<b>Title: Replacement of exhaust manifold</b>		
<b>AG-SB-2023-02-B-EN</b>	<b>Effective Date: 01.04.2023</b>	<b>Compliance Category:</b>  <del>A - MANDATORY</del> <del>B - RECOMMENDED</del> <del>C - OPTIONAL</del>
<b>Applicability</b>		
<b>Aircraft type &amp; model:</b>  <b>Cavalon 915iS</b>	<b>Affected Serial number(s):</b>  <b>All Cavalon 915iS</b>	
The maintenance manual to be referenced is this stated or subsequent issue.		As per AutoGyro website
This form is the response from AutoGyro GmbH either against a problem found in the product in service requiring a containment or rectification action, or as service information for aircraft modification incorporation. For help, contact <a href="mailto:airworthiness@auto-gyro.com">airworthiness@auto-gyro.com</a> .

**Reason and overview of the Service Bulletin (cause of problem if known)**

Illustrations

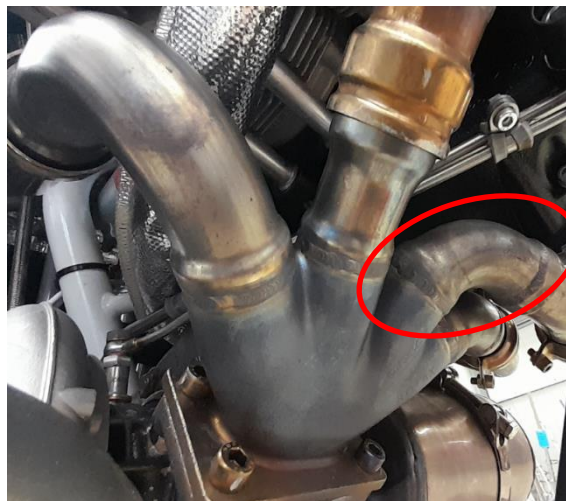
A number of early generation Rotax 915iS exhaust manifolds were found to have cracked in service. This early generation was superseded in 2021 by a new design, shown in service to be reliable.  
It is recommended to replace the old version.

The difference between both versions is an improved welding at the exhaust connection from cylinder two.

The exhaust manifold is changed in accordance with the Rotax engine maintenance manual.

The manifold is Rotax part number 979563.  
AutoGyro provides a kit containing the required service components, part no. 48658, available from the AutoGyro on-line shop.
